FTAA - OceanaGold – Fast-track Approvals Act 2024 – Waihi North Project Application [FTAA-2504-1046]

Resource Use Directorate Waikato Regional Council Memorandum

File No.:	60 50 02Q
Date:	25 th August 2025
To:	Sheryl Roa
From:	AnaMaria d'Aubert
Subject:	Memorandum in response to Minute 1 of the Expert Panel on the substantive application Waihi North [FTAA-2504-1046]

STORAGE 3- EMBANKMENT PROFILE TYPICAL SECTION SHEAR KEY UNDERCUT (2/513)
 scale 1:1250

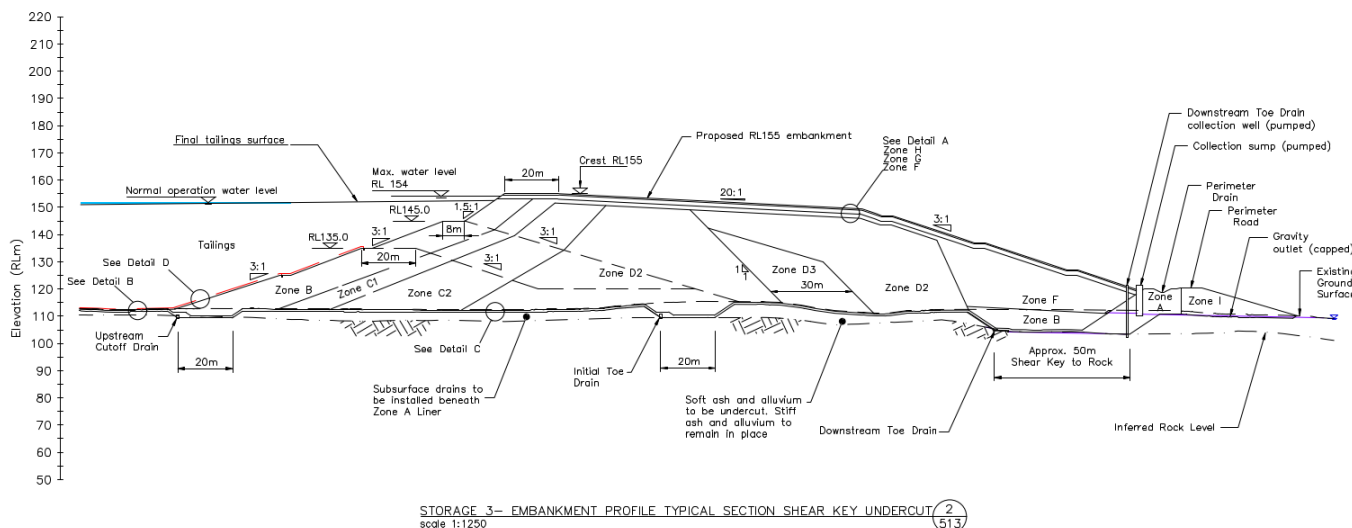
- Downstream construction
- Shear key beneath embankment in vicinity of 'Paleo Gully' feature.
- Zoned construction
- Underdrainage

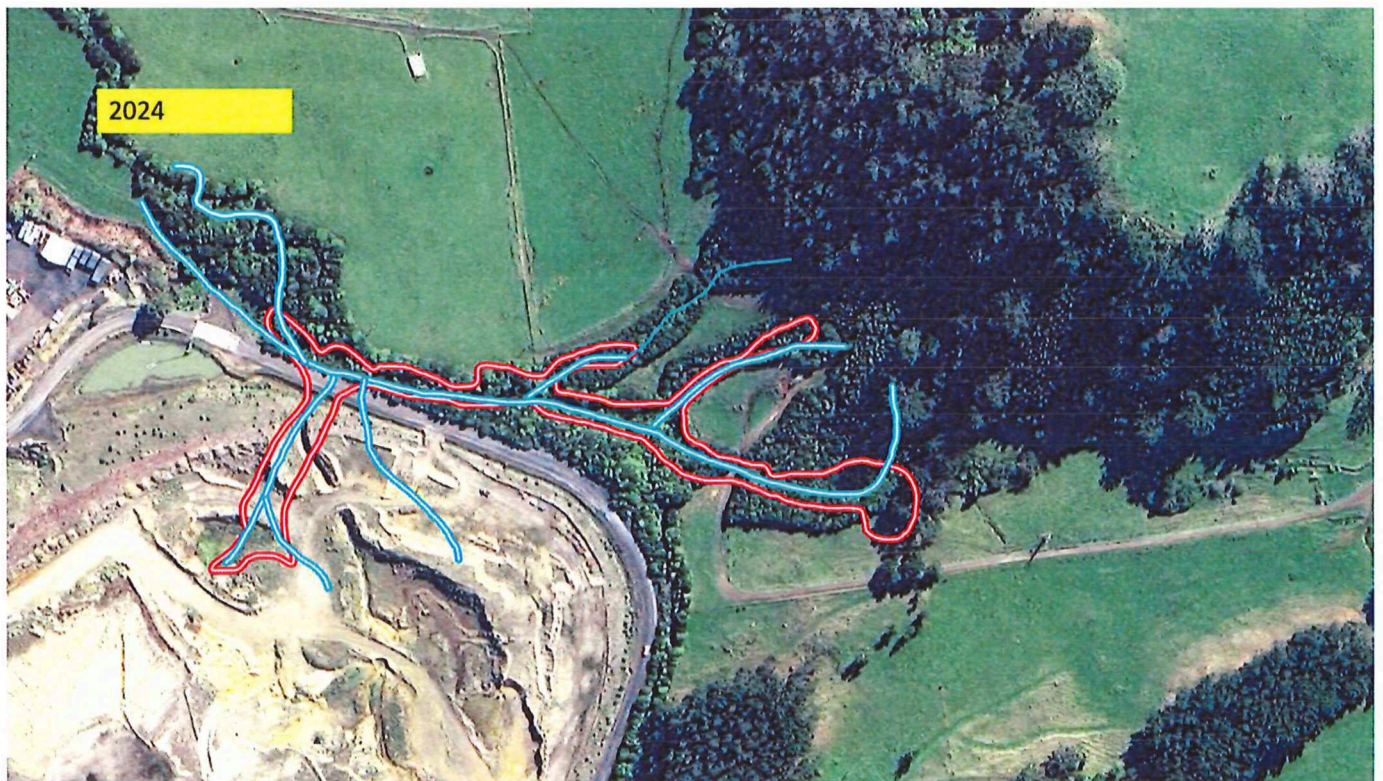
In my 30+ years of experience field-assessing wetlands, this image feature usually indicates the presence of obligate or facultative wetland herbaceous species such as *Juncus* rushes, *Carex* or *Cyperus* sedges, Mercer grass, creeping bent, swamp millet, willow weed, buttercup species, or, if very wet, reed sweet grass. Some of these species are noted by Ian Boothroyd (letter to Oceania Gold, 10 November 2021) as naturally occurring in the TB1 wetland.

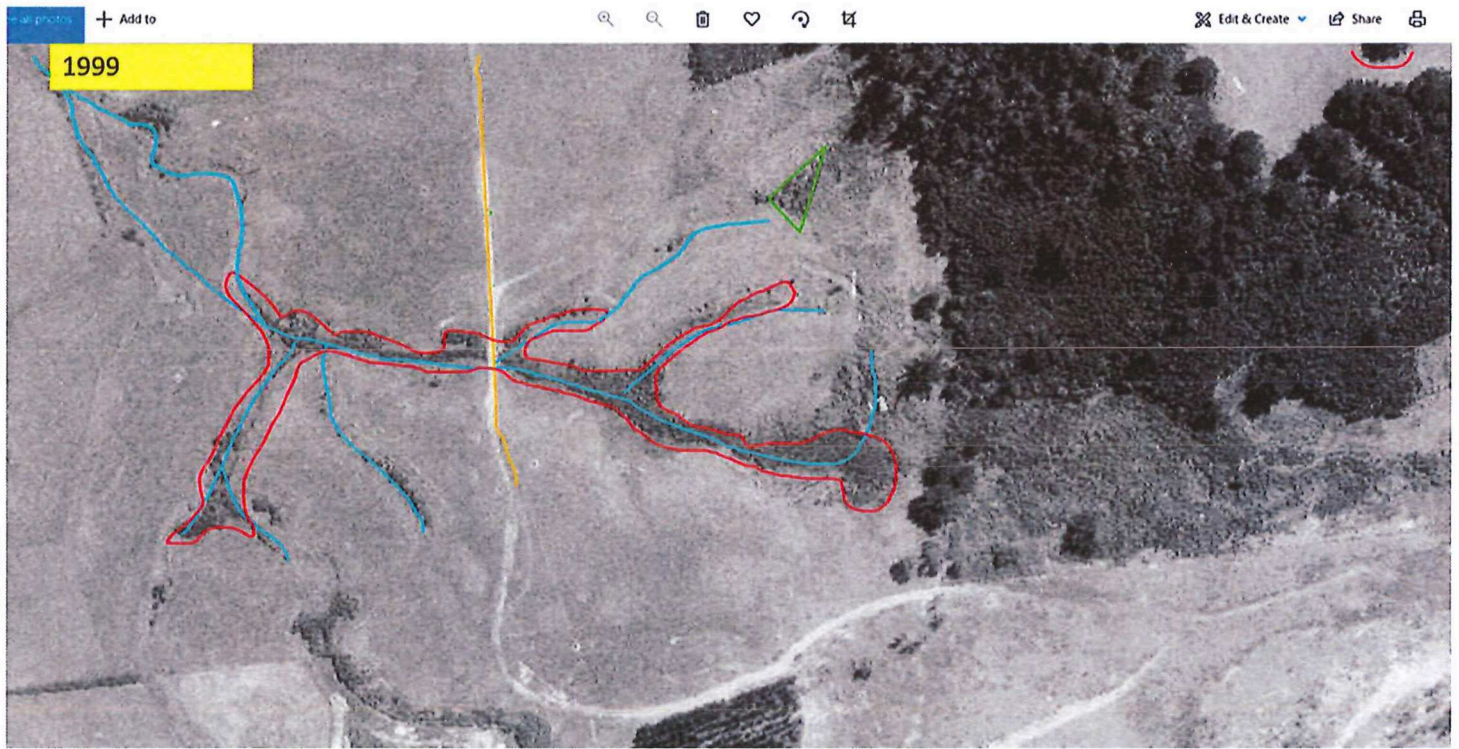
The gully areas in the early air photos also resemble similar aged images of locations that I have visited and know to be areas of swamp millet and other herbaceous wetland species (see Figure 2). However, note that it is impossible to determine if the historic areas of wetland met the pasture exclusion test of the NPSFM because individual species cannot be identified from the images.
